City of Santa Fe, New Mexico

memo

2025-011230-HDRB, 527 Agua Fria St. units 1, 2, & 3, Westside-Guadalupe Historic District, Contributing, Osage Design Studio, agent for Neirika, LLC, owner, proposes to construct a 36 sq. ft. addition, replace windows and doors, raise two sections of roofing, re-roof, stucco, and other repairs. Exceptions are requested to 14-5-2(D)(5)(a) for the replacement of windows on primary facades.

Figure 3: Window Schedule

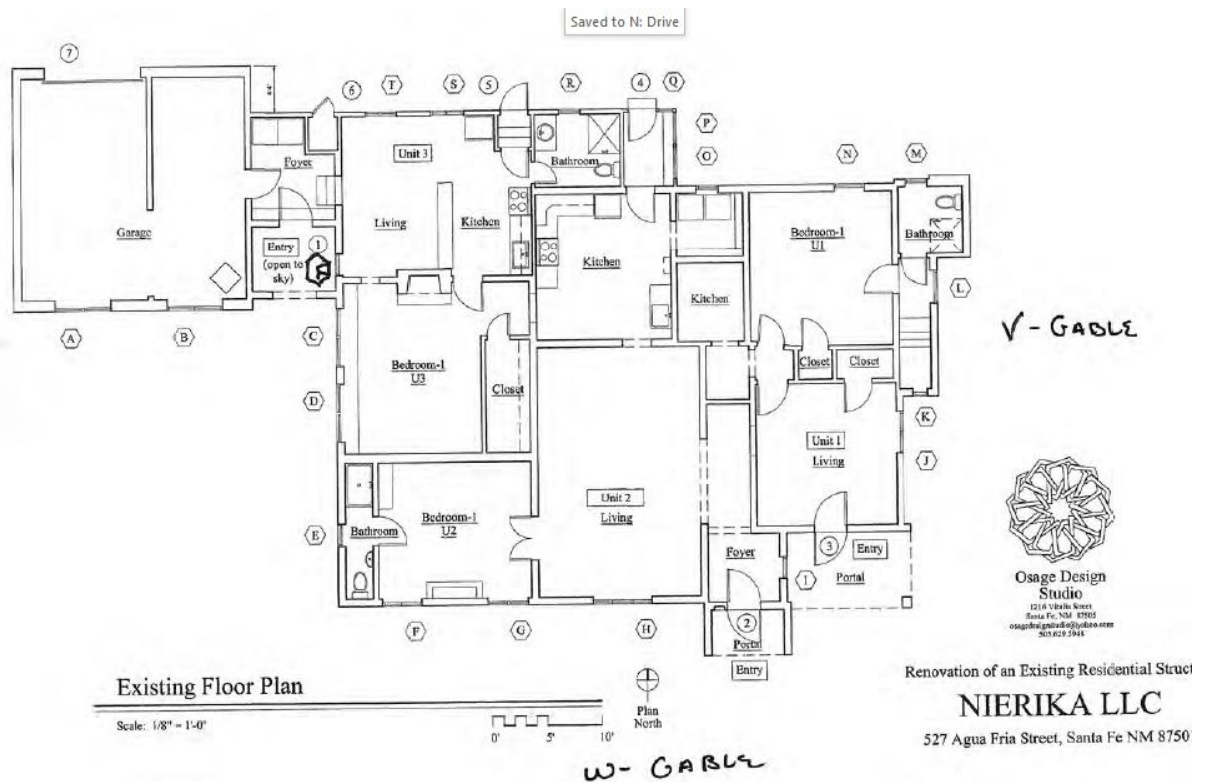
- a. Window replacement in the same size opening at F, G, H, I, J, L, M, O, P, R, S, T, and V. Windows F, G, H, I, and J are historic and restorable. Window O is historic; however, unrestorable. Windows L, M, P, R, S, T, and V are non-historic. Windows F, G, H, I, J, and L are all located on primary facades.

Staff Response: Staff finds that this criterion is not met for items Items 1a, 1g, 1h, and 1l. The windows are deemed as repairable per the window assessment. Replacing historic windows when unnecessary does damage the character of the historic district.

Staff Response: Staff finds that this criterion is not met. Window replacement for the non-historic window L, can be considered because this window is non-historic, irreparable, and will be replaced in the same size openings. However, window replacement for the historic windows F, G, H, I, J, which can be repaired; repair is not under consideration in this application. According to the window assessment rating, these historic windows are in satisfactory condition and, therefore, are repairable. There is no hardship in retaining these windows.

Replacement of the non-historic doors can be considered. However, the front door that arcs at the top to match the portal is unique and a part of the character of the building. The door shape should be retained.

1. Staff finds that the exception criteria have not been met and recommends denial of the exception to section 14-5-2(D)(5)(a) for replacement of historic windows on primary facades (Items 1a, 1g, 1h, and 1i).
2. Otherwise, staff recommends approval of the other elements of the application (items 1b, 1c, 1d, 1e, 1f, 1i, 1j, 1k, and 2-9) as they comply with 14-5.2(D) General Design Standards for all Historic Districts, and 14-5.2(I) Westside-Guadalupe Historic District Design
